**DOCUMENT 00 90 00
ADDENDUM**

ADDENDUM: 2

DATE: JANUARY 8, 2026

PROJECT: HOUSING AUTHORITY OF THE CITY OF LA CROSSE
2025 CAPITAL IMPROVEMENT PROJECTS
1307 BADGER STREET
LA CROSSE, WISCONSIN 54601
PROJECT NO. 25046

1 2ND-9TH FINISH FLOOR PLAN
1/8" = 1'-0"

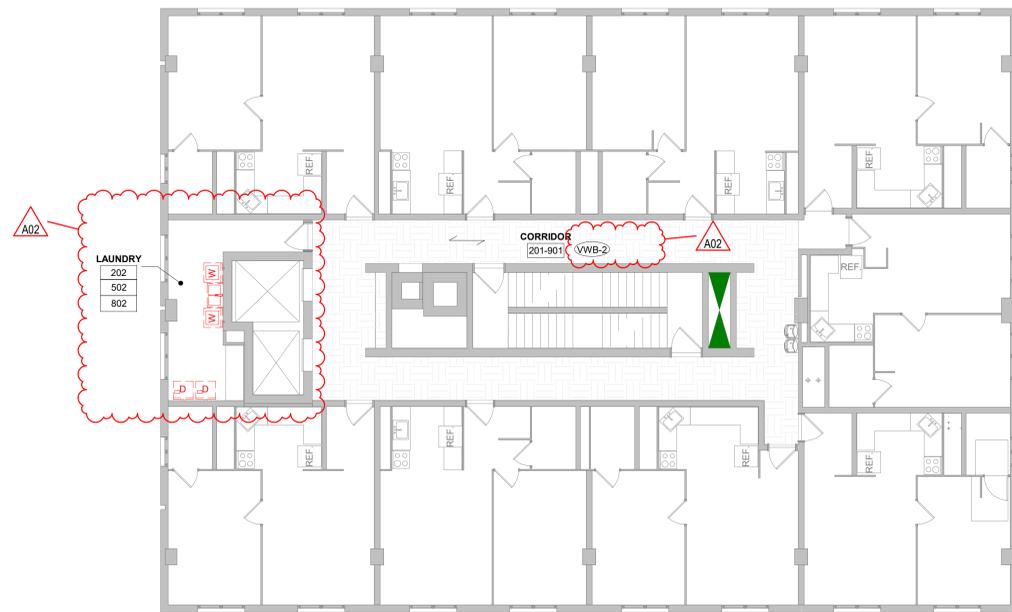
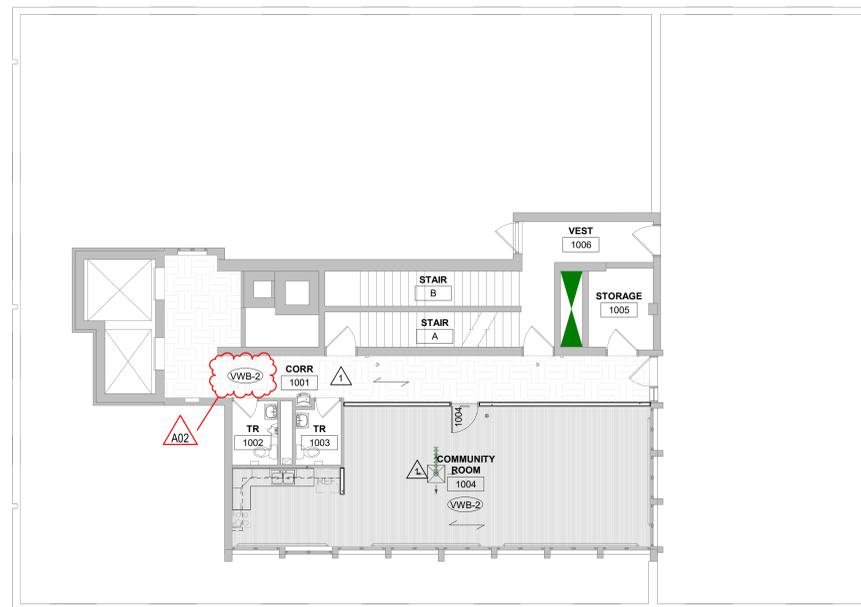
11. Sheet ID410 FINISH FLOOR PLAN 30"x42"
 - a. See the revised sheet included in this addendum. Disregard the previous version.
 - b. Revised detail 1 including:

- i. Removed floor finishes from abandoned laundry rooms.
 - ii. Removed keynote 1.
 - iii. Corrected VWB designation.
 - c. Revised detail 2 to correct vinyl wall base designation.

- d. Added detail 3 to add new laundry room finish plan.
12. Sheet P400 DEMO PLANS 30"x42"
 - a. See the revised sheet included in this addendum. Disregard the previous version.

3 1ST FLOOR DEMO PLAN
1/4" = 1'-0"

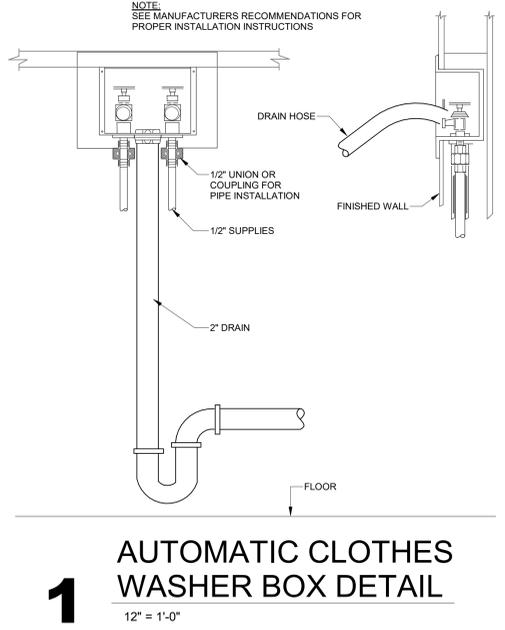
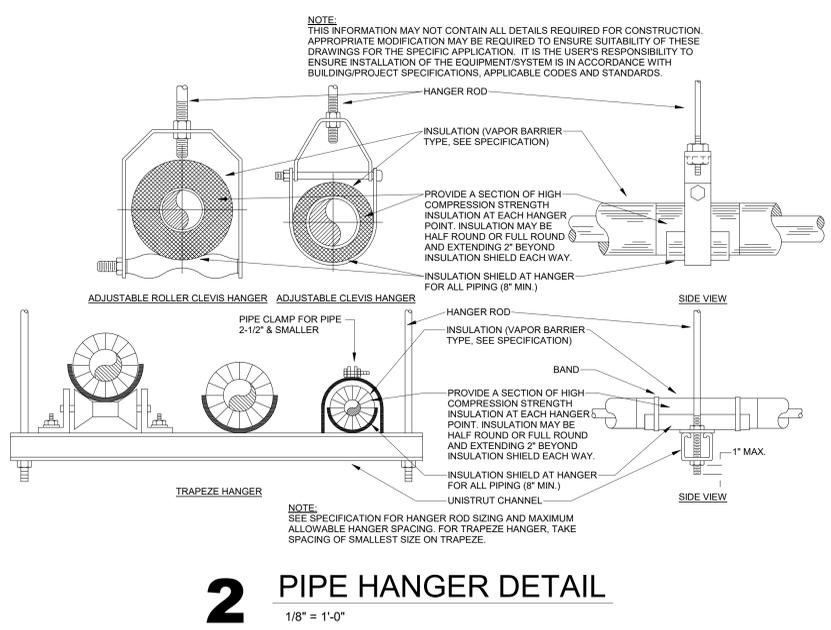
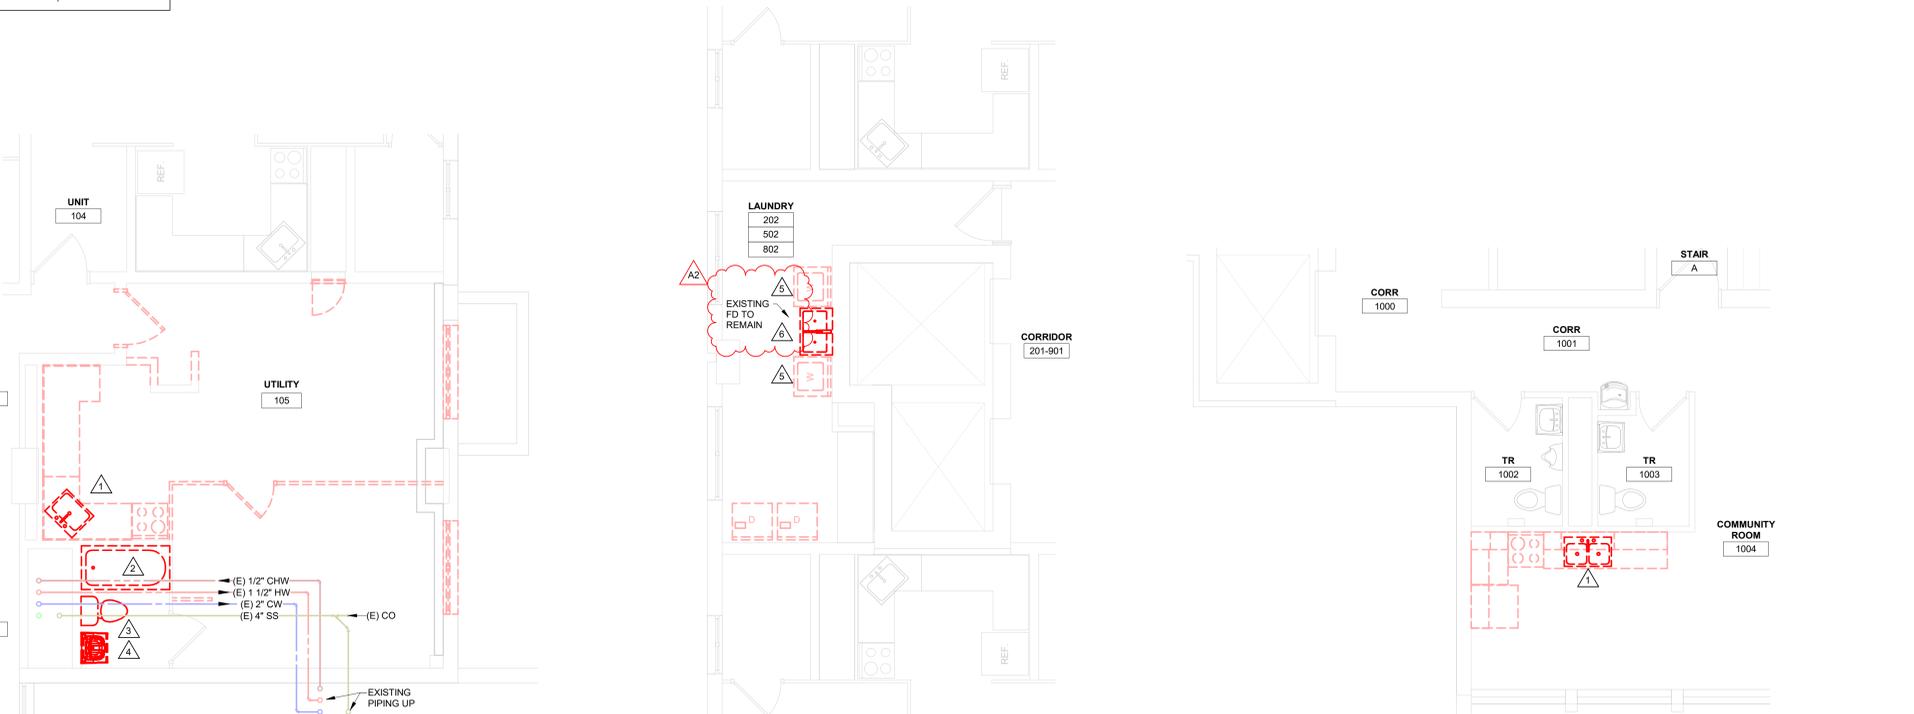
- b. Fixture removal schedule updated.
 - c. Laundry room removal fixtures updated.
13. Sheet P401 REMODEL PLANS 30"x42"
 - a. See the revised sheet included in this addendum. Disregard the previous version.

P401

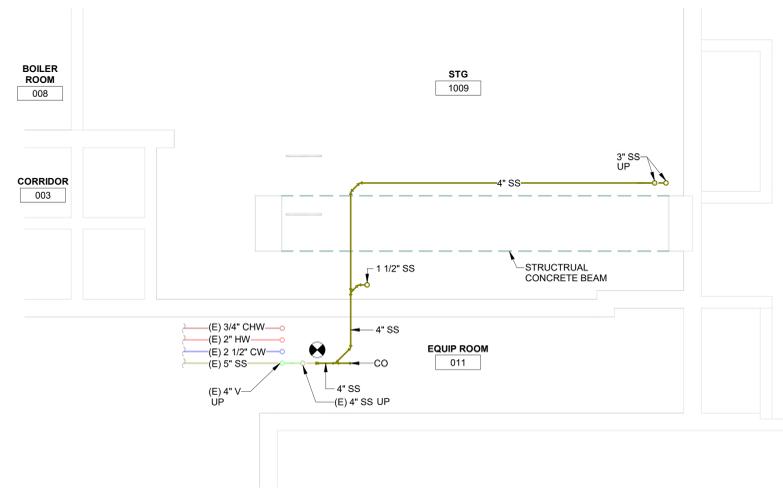
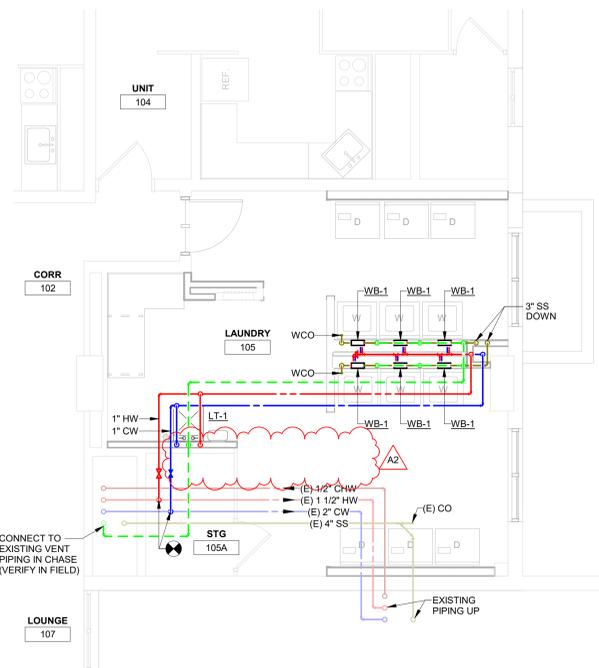
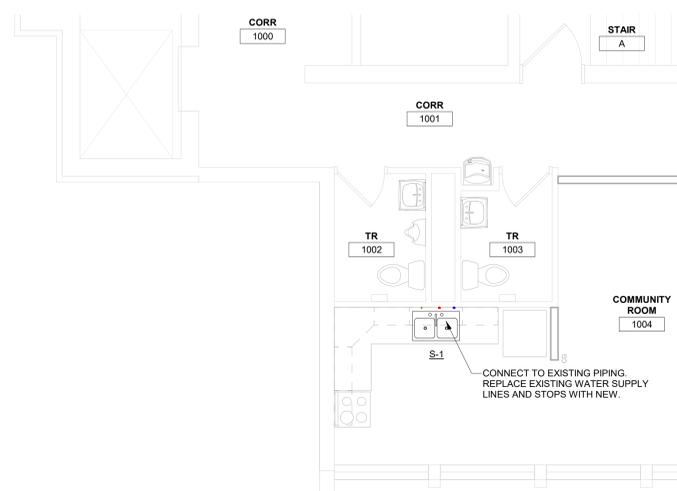
- b. Storage room 105A access panel note removed.
 - c. Laundry tub (LT-1) piping in new wall.
14. Sheet M410 stoffel court remodel sheet 30"x42"
 - a. See the revised sheet included in this addendum. Disregard the previous version.

3 LAUNDRY ROOM REMODEL FLOORS 2,5,8
1/8" = 1'-0"

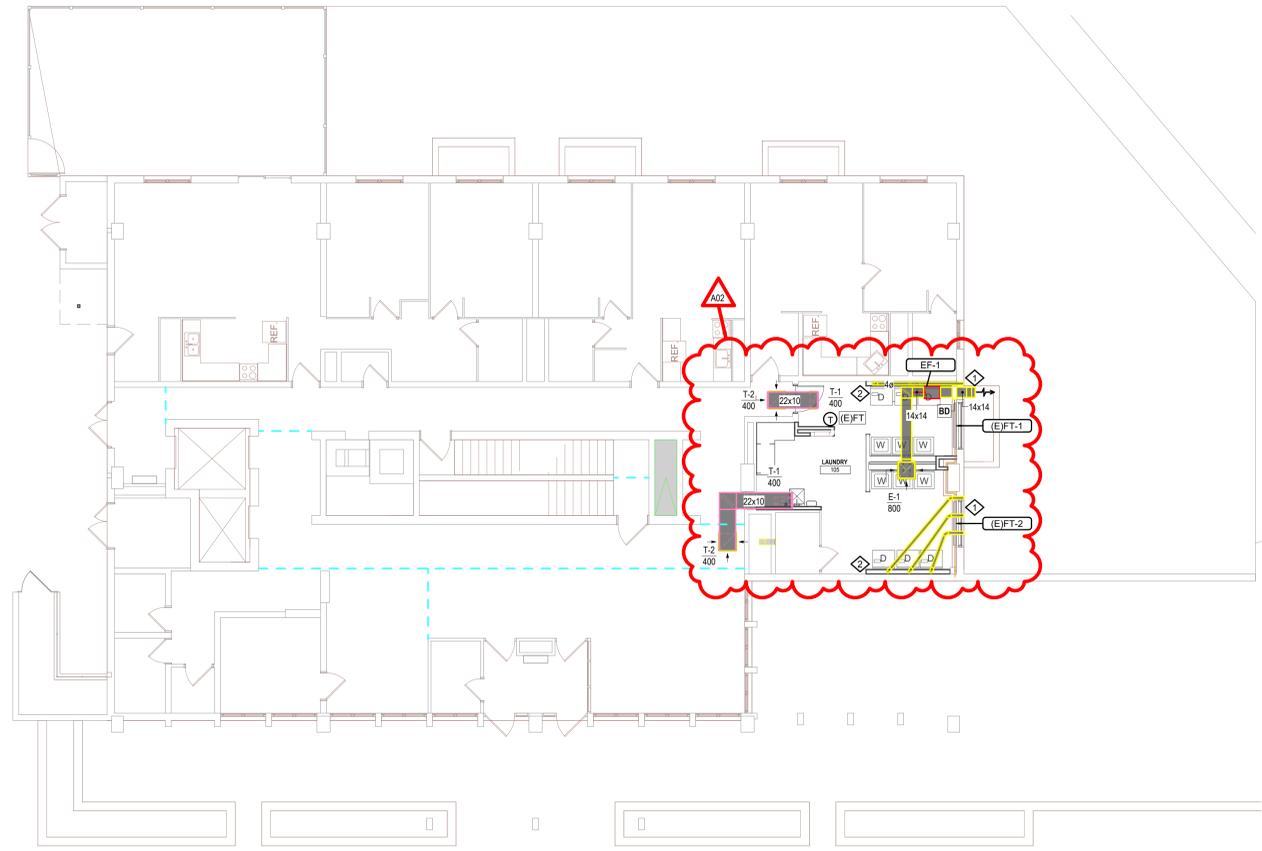
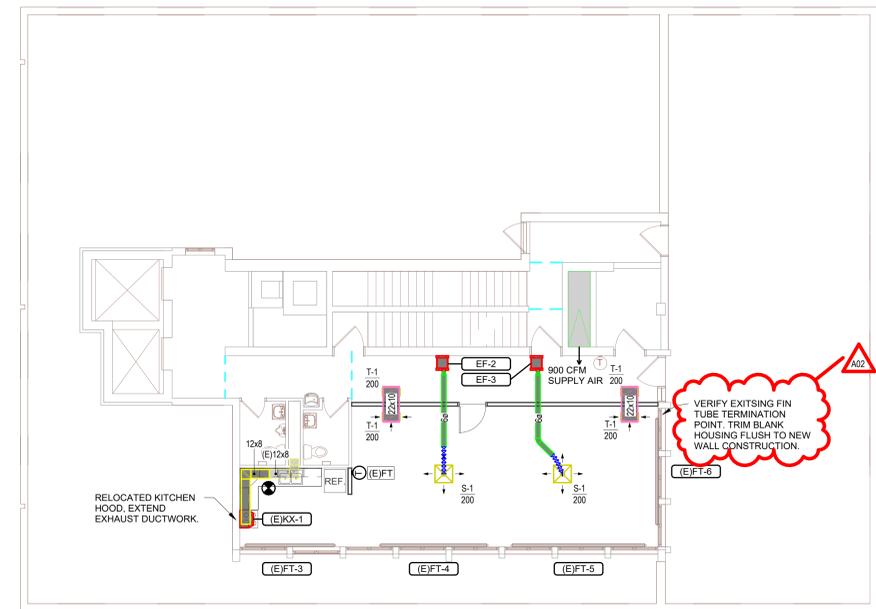
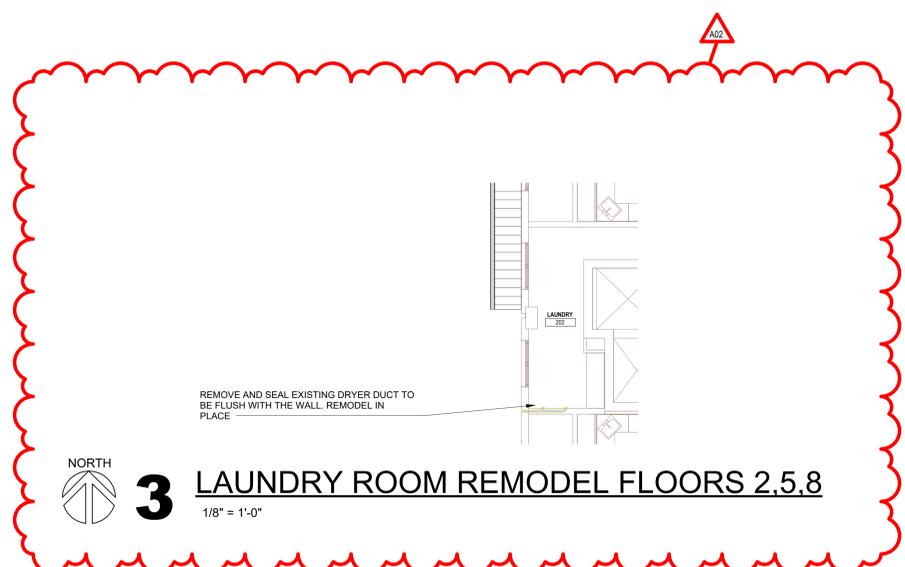
- b. Revised lobby and hallway diffusers.
 - c. Revised location of EF-1.
 - d. Added exhaust grille for EF-1 and relocated to ceiling grid.
 - e. Revised dryer exhaust.

- f. Added notes to requiring verification of (E)FT-6 length ant trim blank housing.
 - g. Added detail 3M410 for existing laundry room.
 - h. Updated schedule.

E420

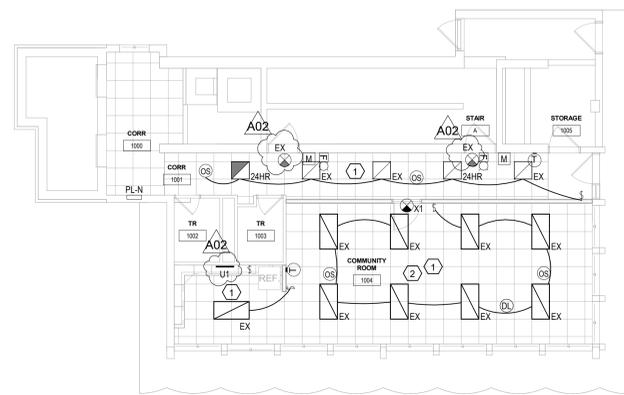
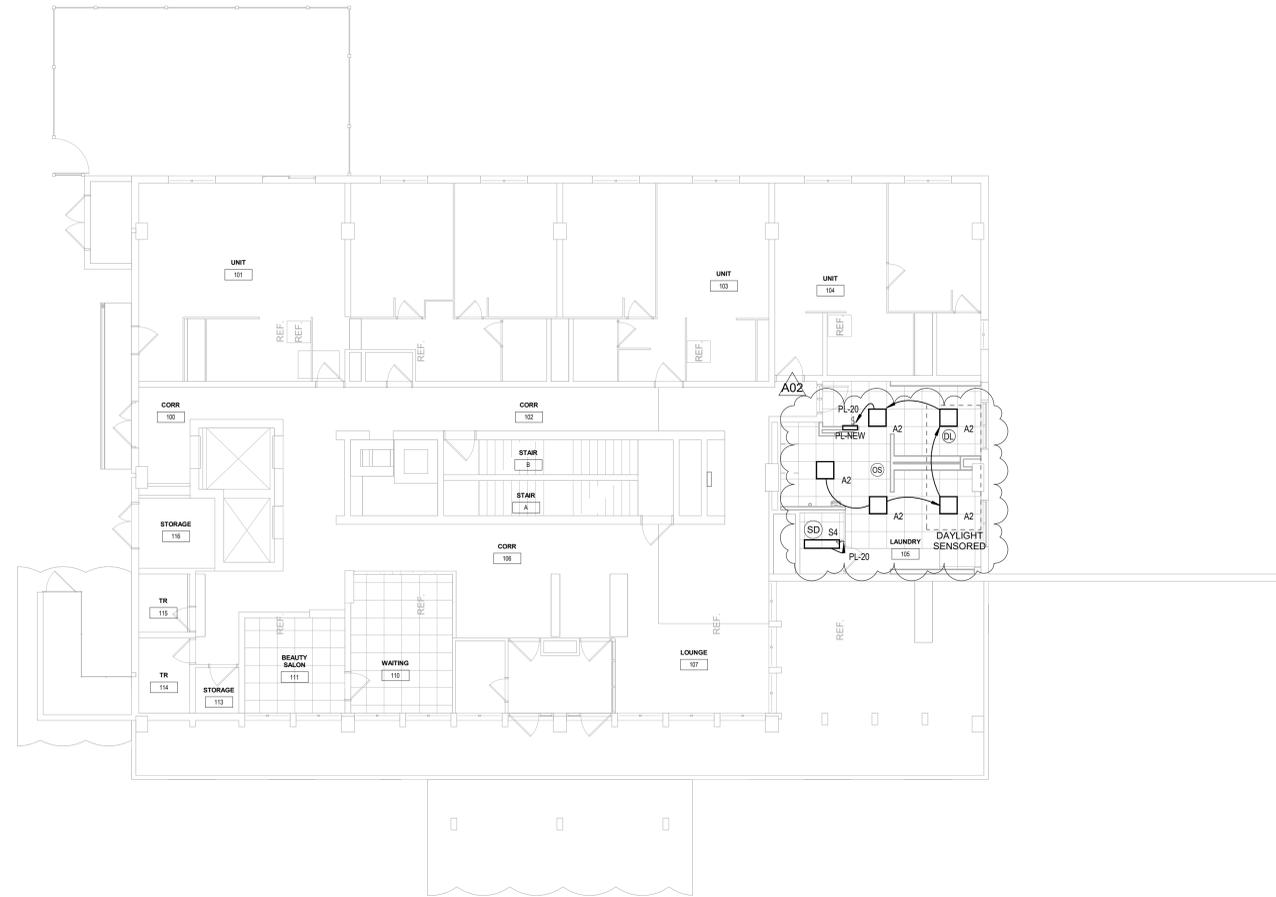
- c. Added keynotes.
 - d. Added #3 floor plan for existing laundry rooms.
17. Sheet E420 LIGHTING PLAN 30"x42"
 - a. See the revised sheet included in this addendum. Disregard the previous version.

- b. Revised fixture designations for first floor lighting plan.
 - c. Revised fixture designations for tenth floor lighting plan.
18. Sheet E460 Riser Diagram and Schedules 30"x42"

2 RISER DIAGRAM - FIRST FLOOR NEW

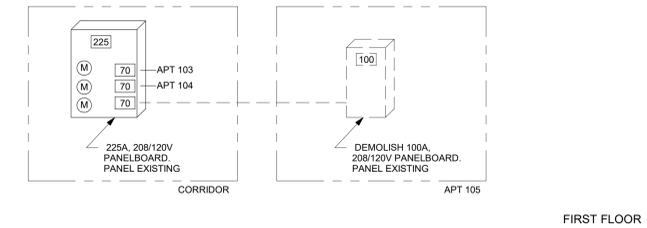
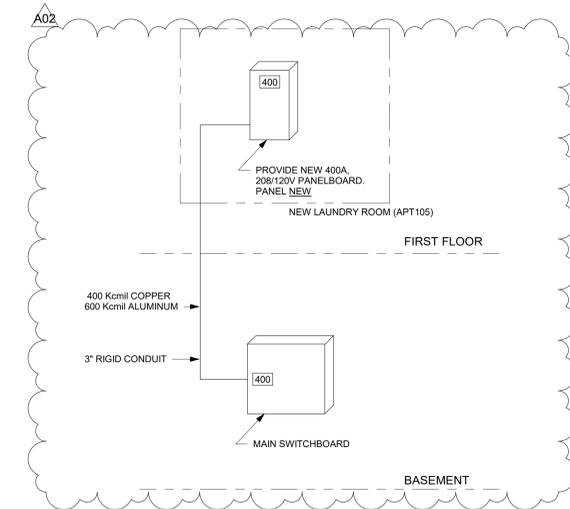
- a. See the revised sheet included in this addendum. Disregard the previous version.
 - b. Revised panel schedule.
 - c. Revised lighting schedule.
 - d. Revised detail #2.

E501

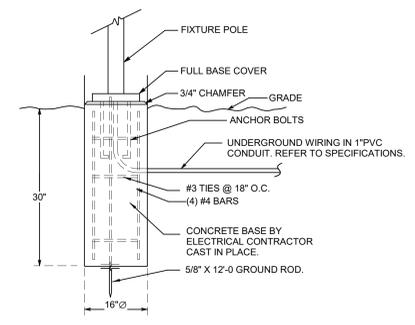
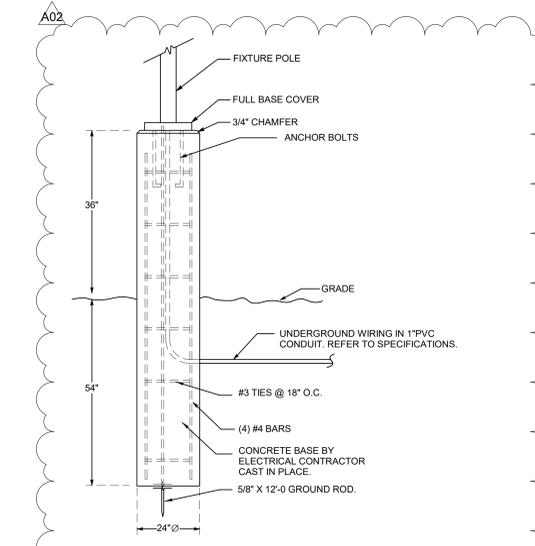
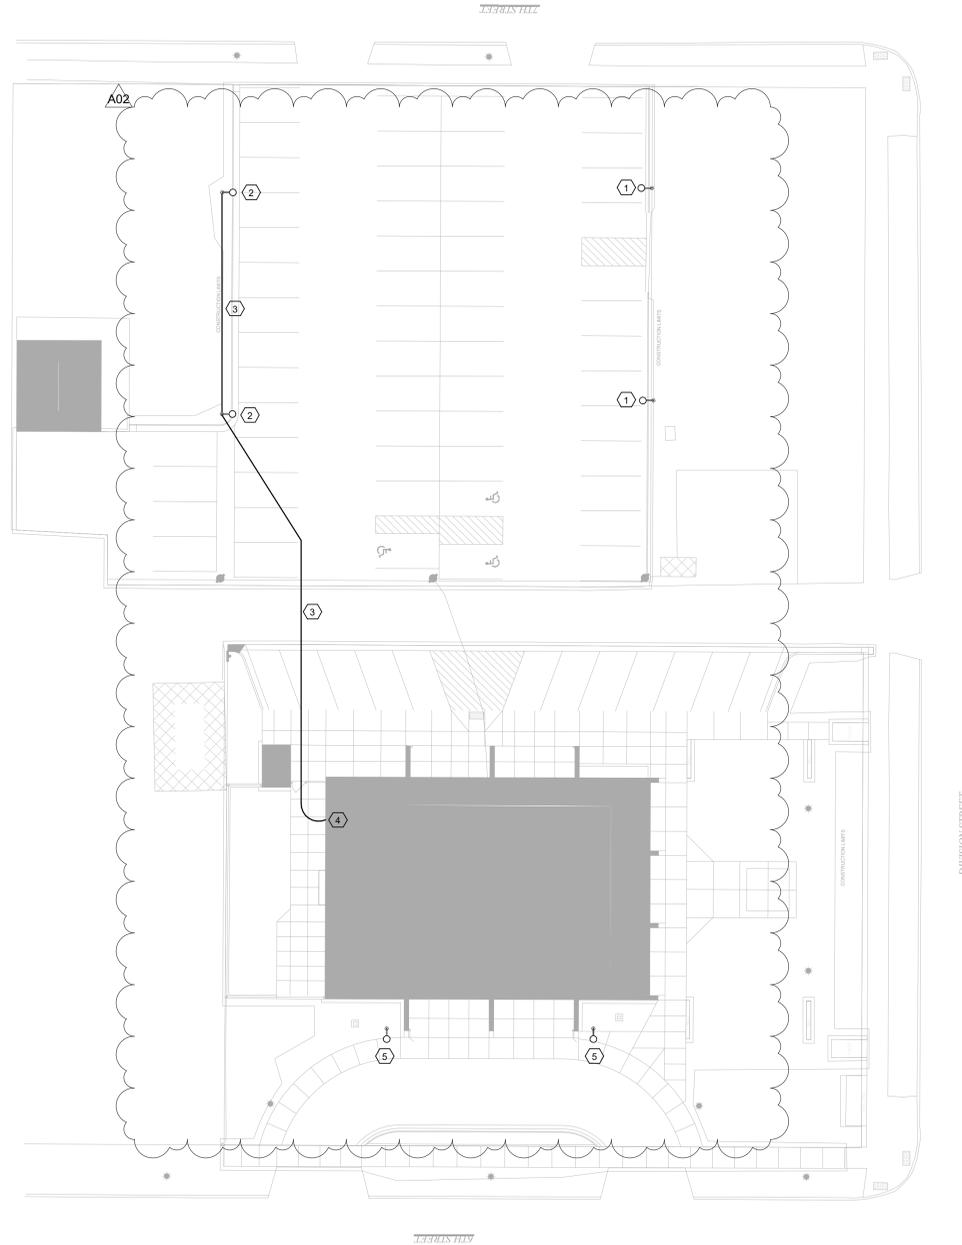
19. Sheet E501 SITE PLAN 30"x42"

- a. See the revised sheet included in this addendum. Disregard the previous version.
- b. Added and revised keynotes.
- c. Added general note.
- d. Added camera conduit.
- e. Revised pole base detail.
